# KENDALL COUNTY

NEW OFFICE BUILDING

## May Monthly Report

Re: KENDALL COUNTY PHASE 1 CLERK BLDG  
Project: 221071

Door 006A

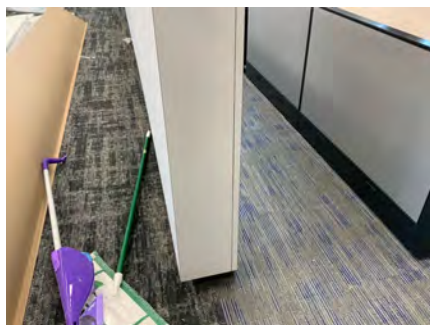
1. Verify location to install panic devices at workstation cubicles.
2. Water was discovered on carpeting near door 118C, verify water is completely dried and did not damage gypsum board and verify carpeting is adequately adhered.
3. Verify if resinous terrazzo flooring material is being applied under mailbox.
4. Exterior double door 006A is missing a hinge, verify this will be installed.
